## IMMINGHAM EASTERN RO-RO TERMINAL DCO APPLICATION

### PINS REFERENCE TR030007

#### WRITTEN REPRESENTATION FROM DFDS

**Figures 5 and 6: Locations of remote stemming areas**

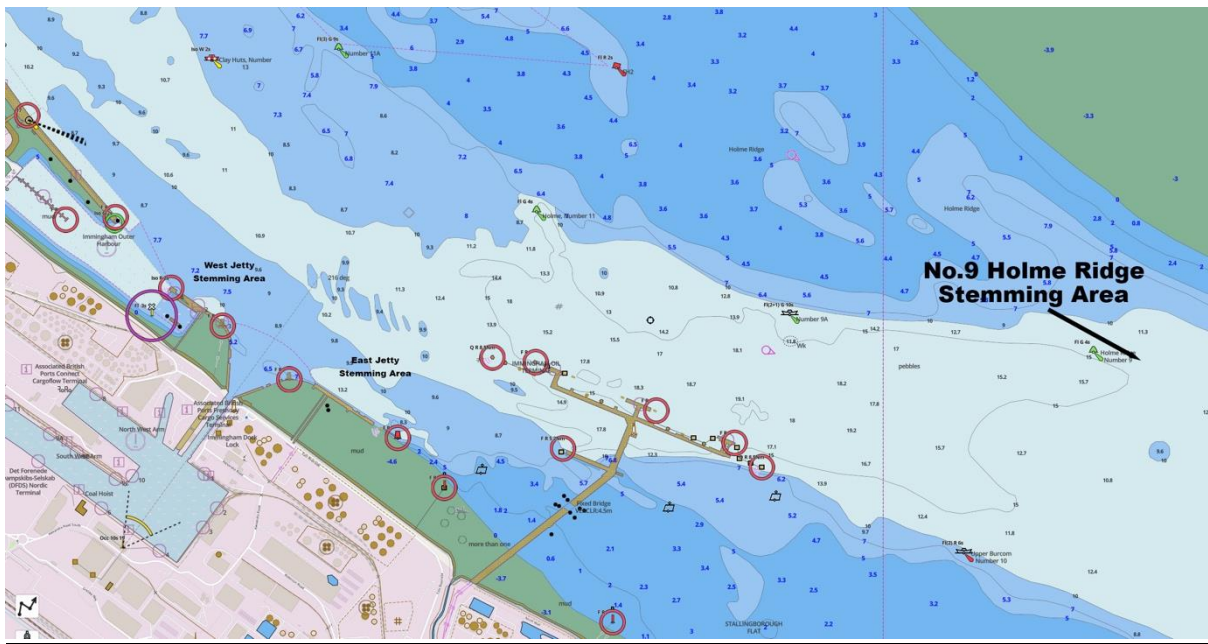
38. The construction of the IERRT will limit or more likely remove the ability of vessels to stem the tide off the east jetty. This will then require vessels to use the west jetty stemming area (if available), slowing down lock approaches on the ebb tide which will lead to delays and a subsequent 'backing up' of inward vessels. This process is managed by The Statutory Harbour Authority's Vessel Traffic System (VTS) under the strict criteria of '*Standing Notice To Mariners S.H.22 'RIVER HUMBER: ENTRY TO IMMINGHAM DOCKS'*' (**Appendix 2** of this document). This notice from the Harbour Master only allows 2 vessels to be within the Humber VTS area bound for Immingham Dock at any time. One vessel is permitted in the stemming areas off the east & west jetties and one vessel close to the No 9 Holme Ridge buoy to the east of IOT. All other inbound vessels are required to wait outside the VTS area 20 nautical miles to the east in the North Sea, as shown in **Figures 5 and 6**.

**Figure 7: simulation with tug barge added**

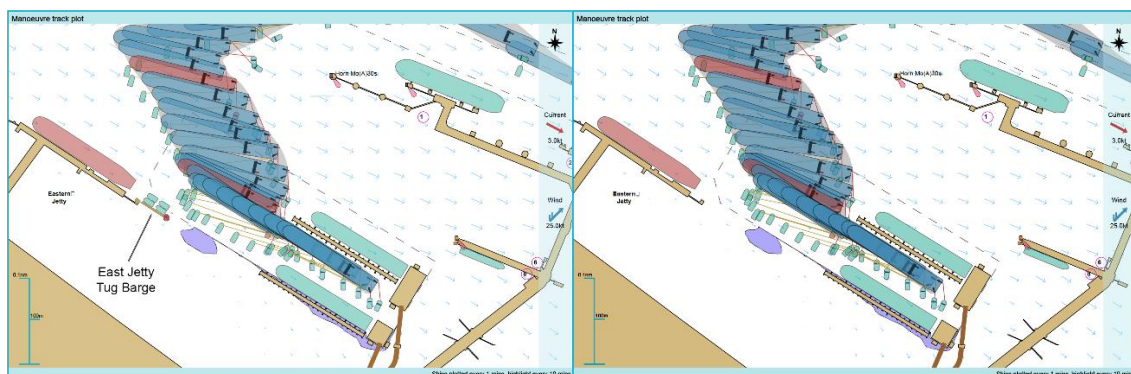
51. The Applicant has not shown the East Jetty Tug Barge in their simulations but it is not clear if it has been omitted accidentally or is to be removed. If the former, then the simulations have been carried out on the wrong basis, and if the latter, the Applicant has failed to explain how the safety issues this will raise will be mitigated. The loss of this key component of estuarial safety would have far-reaching effects for all Humber traffic and general safety issues for all river users.

52. **Figure 7** below shows the tug barge added to one of the simulations (left) with the original simulation diagram on the right. This is simulation 4 from [\[APP-090\]](#).

53. If however this is an error in the simulations and that the East Jetty Tug Barge is to remain in its current position this would again bring into question the validity of the simulations. If the barge had

### Figure 8: Extract from the Applicant's Simulation Report

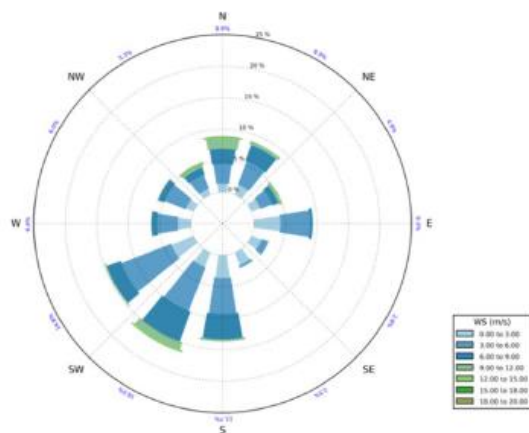
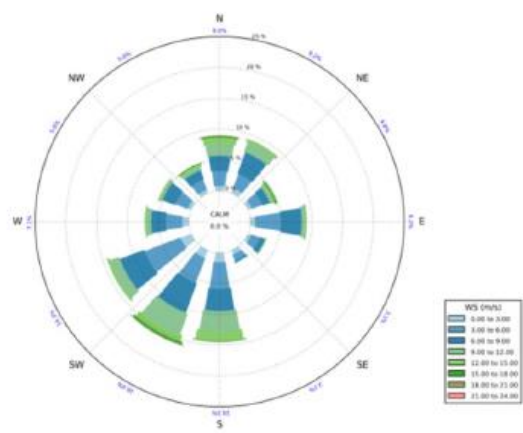
61. However it is stated in the Applicant's simulation report (DJR6612-RT002-R03-00), originally shared with DFDS, that the wind data used was taken from 12 months of recordings from the Immingham MCC, as shown in the extract below at **Figure 8**.

62. This data looks different from the HUY (HumberSide Airport) data used in the Navigational Risk Assessment [APP-089] (page 12) – see **Figure 9** below:

**Figure 10: The Applicant's Simulation 24, using Berth 3**

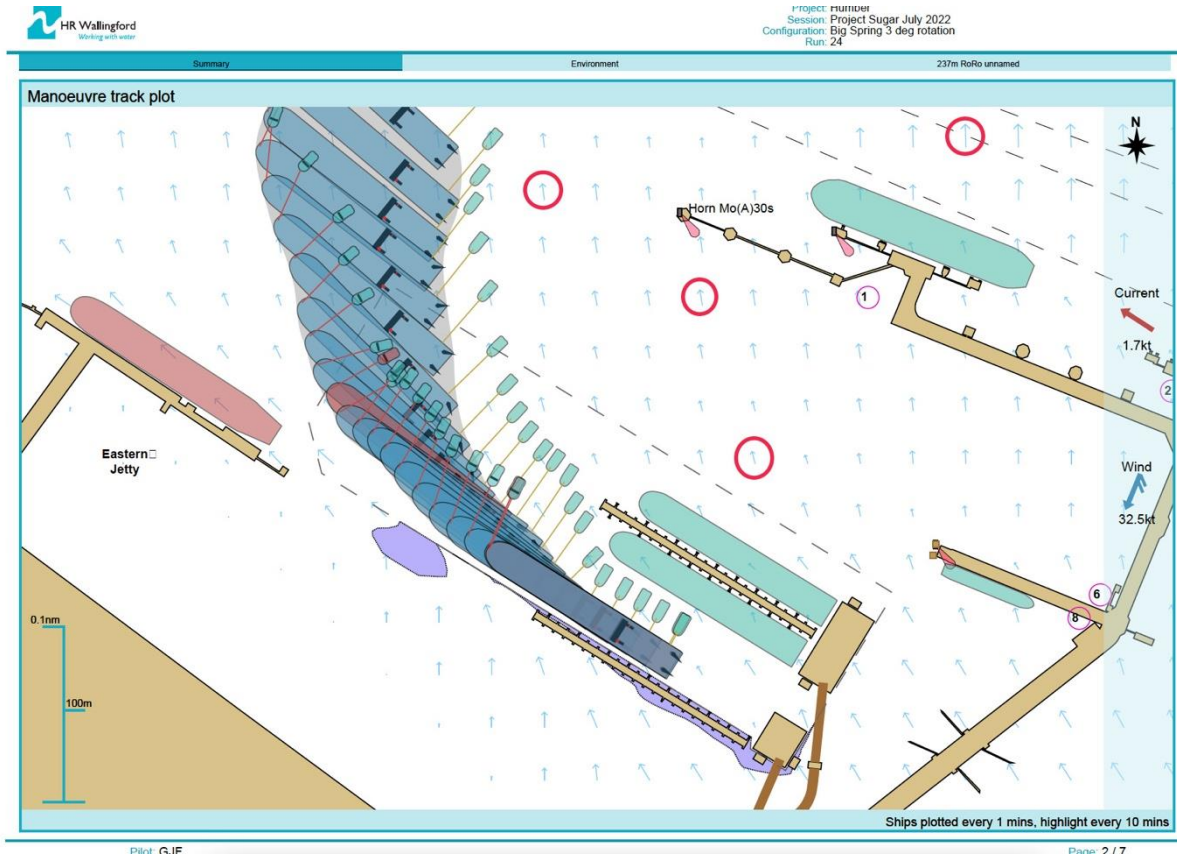
114. Only one Berth 3 simulation has been undertaken by the Applicant in 101 simulations undertaken (simulation 24 – see **Figure 10** below) which is inadequate given the complexity this berth presents. The manoeuvring for berths 2 and 3 will be significantly different depending upon the direction of the wind. The prevailing wind in the area is south-westerly resulting in the wind pushing vessels off the berth. This creates severe manoeuvring issues given the confined nature of the IERRT especially when vessels are berthed on berth 2. It also creates potential difficulties in clearing the chemical tankers berthed on the Immingham East Jetty in northerly winds. The failure to adequately simulate these means the risks involved with Berth 3 have not been adequately considered.

115. It is also of note that in the solitary Berth 3 exercise the tide appears to be completely different as it is moving in a northerly direction which is diametrically opposed to the wind direction in the

simulation making the manoeuvre significantly easier. None of the experienced mariners nor our consultants have ever experienced a tide running in this direction in these locations with which we are familiar.

**Figure 11: bow thruster use for Run 14**

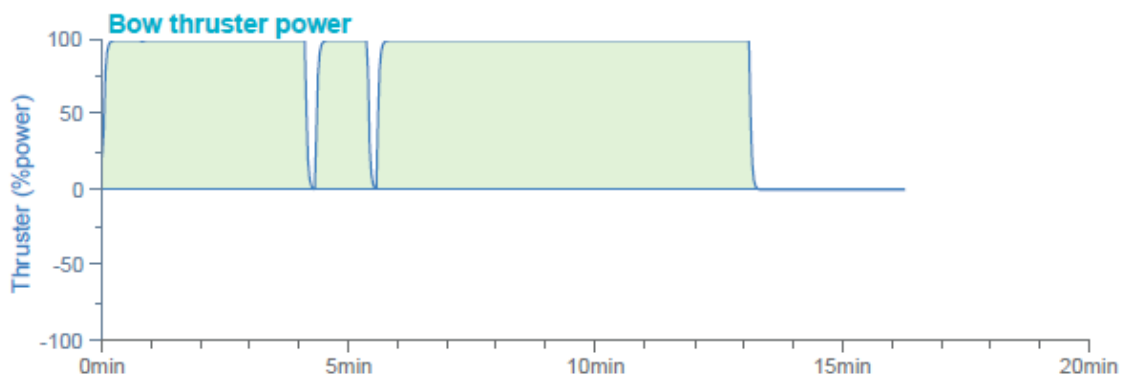
121. In many of the simulations there was excessive and prolonged use of the bow thruster unit. These units designed to give greater control of the vessel during manoeuvring are intended for fine control of the vessel's head.

122. Despite this in some simulations the bow thruster unit is used at full power for up to 22 minutes continuously. The unit is not intended for this level of extreme operation and this is clearly not consistent with a 'controlled manoeuvre' as it leaves nothing in reserve, as can be seen from **Figures 11-13** below:

**Figure 14: propeller use for Run 25**

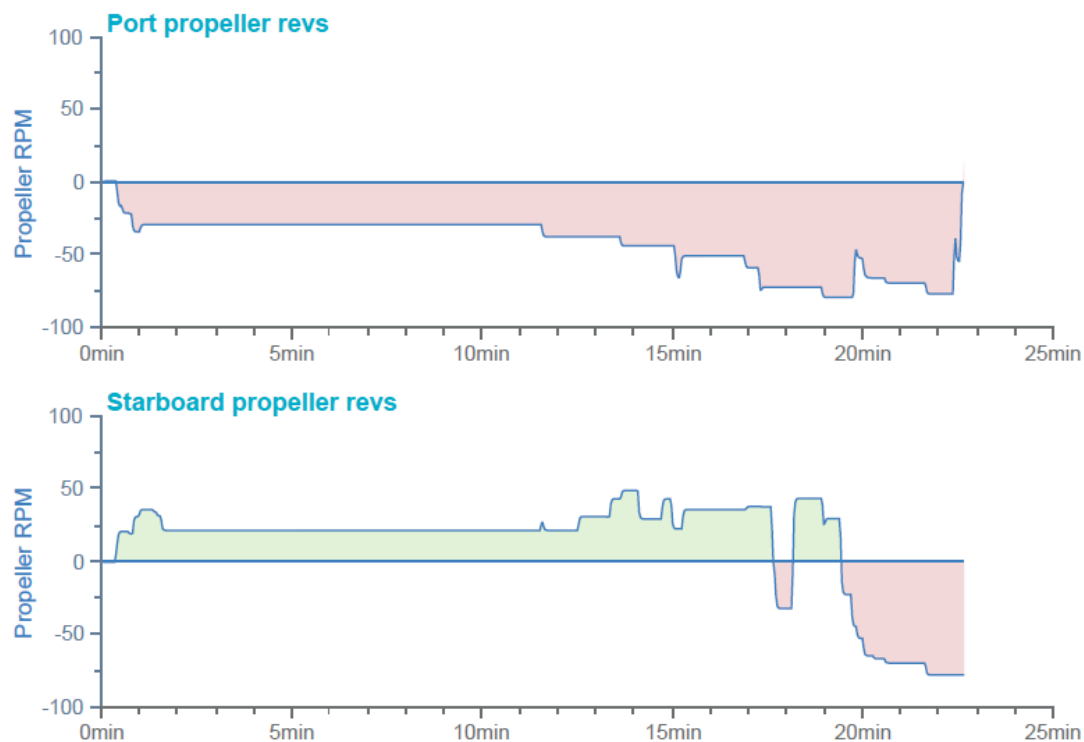
124. As an example, run 25 can be viewed (**Figure 14** below). Both propellers are used with a stern pitch of up to 75%, which would create excessive wash and turbulence in the area where the aft tugboat is working.
